<b>Customer</b> : CU-DAR001 Dart Helicopters Services	<b>Drawing Name</b> : BASKET RIB
<b>Job Number</b> : 46629	
<b>Estimate Number</b> : 10404	
<b>P.O. Number</b> :	<b>Part Number</b> : D31663
<b>This Issue</b> : 19/03/2009 <b>S.O. No.</b> :	<b>Drawing Number</b> : D3166 REV A2
<b>Prsht Rev.</b> : NC	<b>Project Number</b> : N/A
<b>First Issue</b> : / / <b>Type</b> : LARGE FAB ASSY	<b>Drawing Revision</b> : A2
<b>Previous Run</b> : 46305	<b>Material</b> :
<b>Written By</b> :	<b>Due Date</b> : 25/03/2009 <b>Qty:</b> 6 <b>Um:</b> Each
<b>Checked &amp; Approved By</b> : <u>JUD 09-03-19</u>	
<b>Comment</b> : Est. A 02.08.23 New issue KJ Est Rev:B 09-01-23 as per DEO D3166-A2 DD verified by:EC

DESIGN #	DRAWN BY CP	DART AEROSPACE LTD HAWKESBURY, ONTARIO, CANADA	
CHECKED #	APPROVED #	DRAWING NO. D3166	REV. A SHEET 1 OF 1
DATE 02.07.10		TITLE BASKET HOOP SCALE NTS	
A	02.07.10	NEW ISSUE	
A1	04.04.08	38 +/- 1 mm 36.0

DRAWING NO. D3166	TITLE BASKET HOOP	REV A1	<b>DART AEROSPACE LTD ENGINEERING ORDER</b>		D.E.O. NO. D3166-A-2	SHEET NO. 1 OF 1	SCALE NTS
DRAWN AJS	CHECKED <i>[Signature]</i>	MFG. APPR. <i>[Signature]</i>	APPROVED <i>[Signature]</i>		DE APPR. <i>[Signature]</i>		
DATE 08.12.11

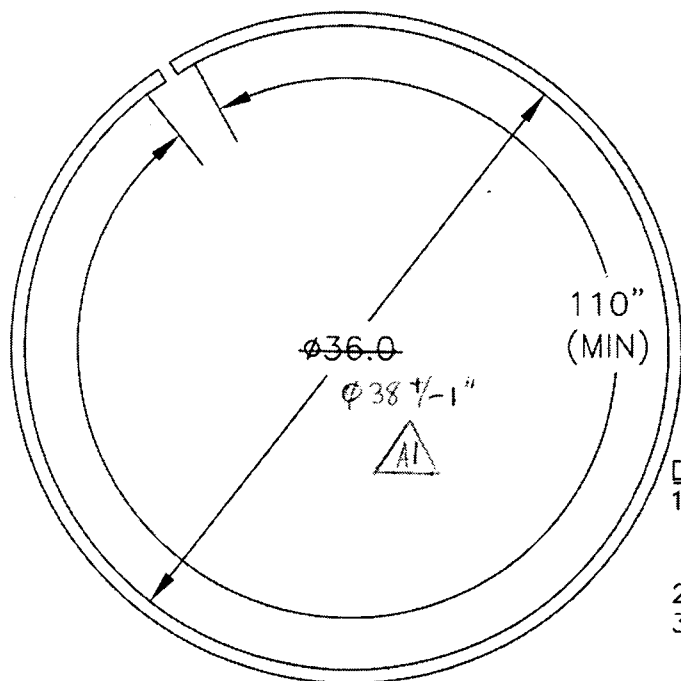
1) MODIFY MATERIAL NOTE FOR D3166-1 AS SHOWN:

2) MODIFY MATERIAL NOTE FOR D3166-3 AS SHOWN:

REASON: SEE PAR 08-005

**IS:**

1) MATERIAL: AISI 304/316 SS, 3/4 X 3/4 X 0.065 WALL SQUARE TUBING,  
60.00" LONG  
REF. DART SPEC M304TS0.750W.065

**IS:**

1) MATERIAL: AISI 304/316 SS, 3/4 X 3/4 X 0.065 WALL SQUARE TUBING,  
120.00" LONG  
REF. DART SPEC M304TS0.750W.065
